IN THE MATTER OF Private Plan Change 95 Pencarrow Estate
Pongakawa to the Western Bay of Plenty
District Plan

**POST-HEARING REPLY EVIDENCE OF DANIEL HIGHT
(ENGINEERING, FLOODING AND NATURAL HAZARDS)
ON BEHALF OF KEVIN AND ANDREA MARSH**

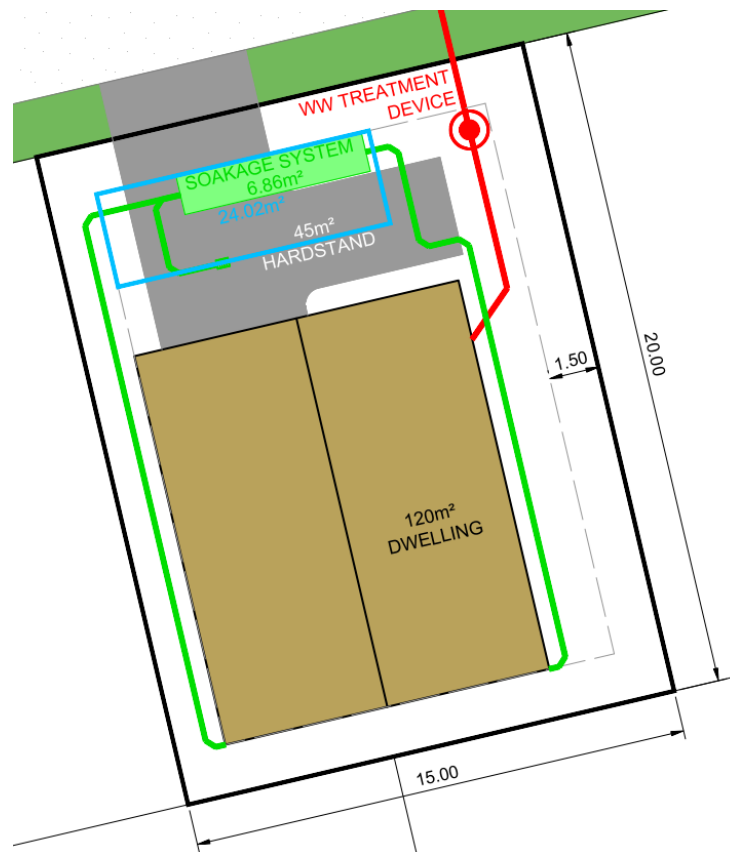
9. In my revised calculations (refer Appendices A and B) I have sized the device such that it can store entire two design storms (the 10-year 60-minute storm, as per the New Zealand Building Code, which these private systems would be designed and consented under), but not necessarily drain within 24 or 48 hours. Such a system can receive two design storms consecutively without surcharging, which I understand meets the intent of the design principle raised by Mr Abraham and Ms Southerwood. I consider this to be an appropriate approach when designing soakage systems in slow soakage soils (which it should be noted this site may not be, but the calculation very conservatively assumes a slow soakage rate). Using this approach, a soakage device with a 24m² footprint is required (much less than the large devices proposed by Mr Abraham and Ms Southerwood), which can be located within the site as per the blue polygon in the image below.
